Three Mile Island Nuclear Station, Unit 2 (TMI-2)
Operating License No. DPR-73
Docket No. 50-320
Heavy Load Travel Inside Containment

HEAVY LOAD HANDLING INSIDE CONTAINMENT
SAFETY EVALUATION REPORT

Response to NRC Comments

**FIGURE 3.3-1
POTENTIAL LOAD/IMPACT AREAS
WITH EQUIPMENT IDENTIFIED
PLAN ELEVATION 347.6**

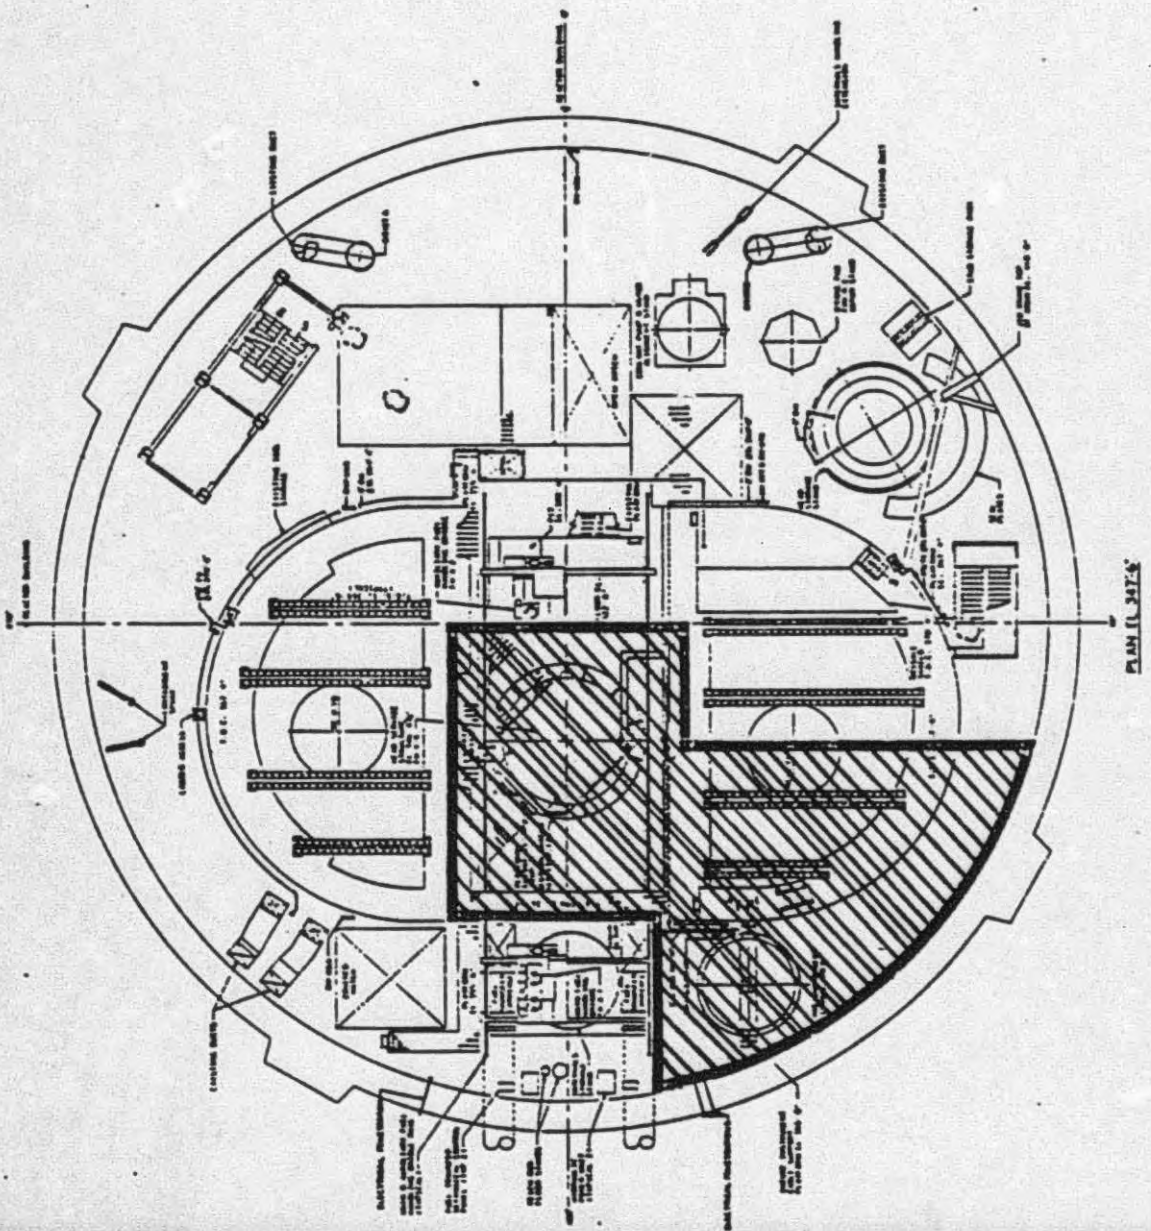
In addition, for Figures 3.3-1, 3.3-2, and 3.3-3, the exclusion area should be indicated by markings on the drawings. Presently, only a boundary is indicated. (There are no indications on the drawing, which may be used apart from the SER discussion, to indicate whether the exclusion area is within or outside of the indicated boundary.)

As stated in the response to Comment No. 2, the handling of heavy loads inside containment is performed via approved UWI or procedure which designates safe load path areas. It is the responsibility of the Responsible Technical Reviewer (RTR) to ensure that the UWI or procedure is in compliance with applicable SER's. The RTR's will be aware of the exclusion areas within the indicated boundaries (See Note 2: "The load path boundary encloses the exclusion areas".) To ensure that the exclusion areas are readily identifiable, those areas have been "cross-hatched" as shown on the attached figures.
